PARTS & SERVICE NEWS

REF NO.	AA00012
DATE	January 21, 2000

SUBJECT: FRAME PASSAGE FOR EAGLE A/C CONDENSER HOSES

PURPOSE: Redesigned sheet to allow more clearance for condenser hoses.

Figure 1

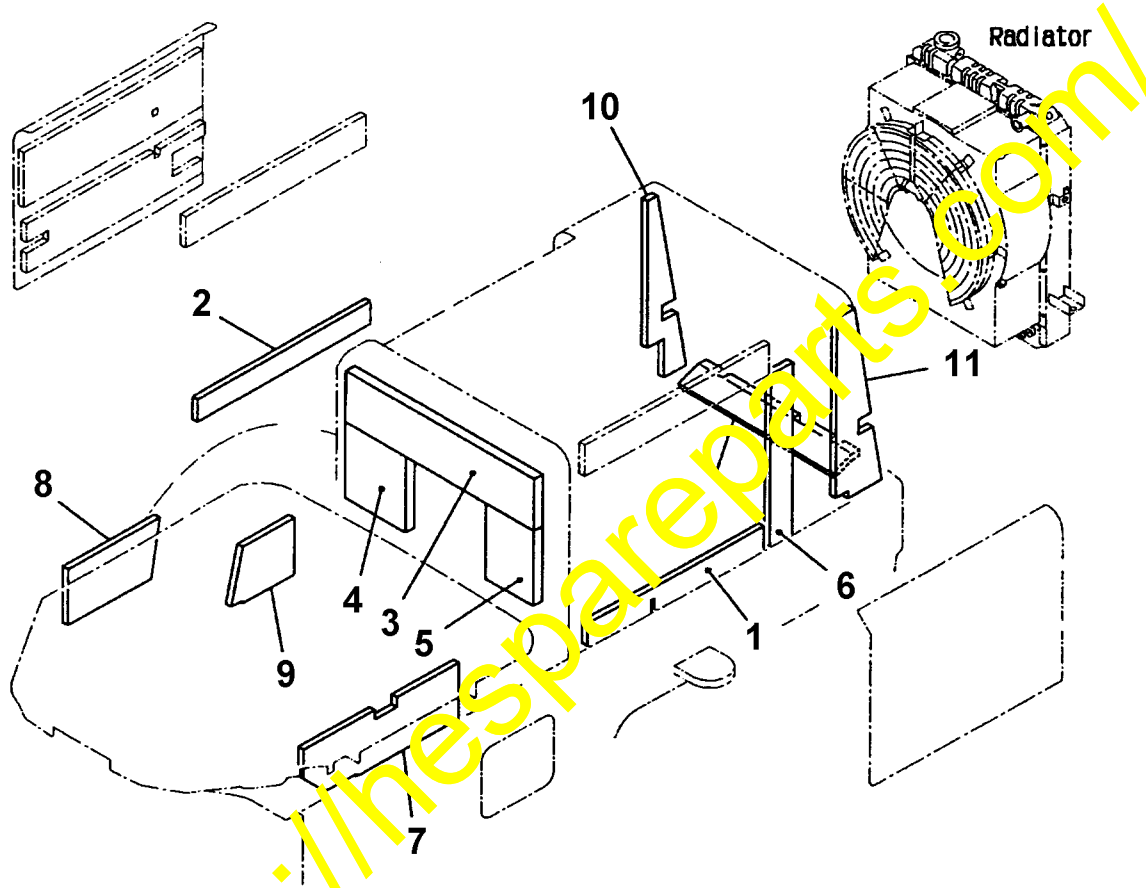
DESCRIPTION: Current sheet does not have sufficient clearance for condenser hoses. New sheet allows for hoses to be installed and removed with greater ease.

NOTE: See Figure 1, page 2

REPLACEMENT PART NUMBER

Item	Part Number	Description	Qty	Remarks
7	417-54-A2120	SHEET, L.H.	1
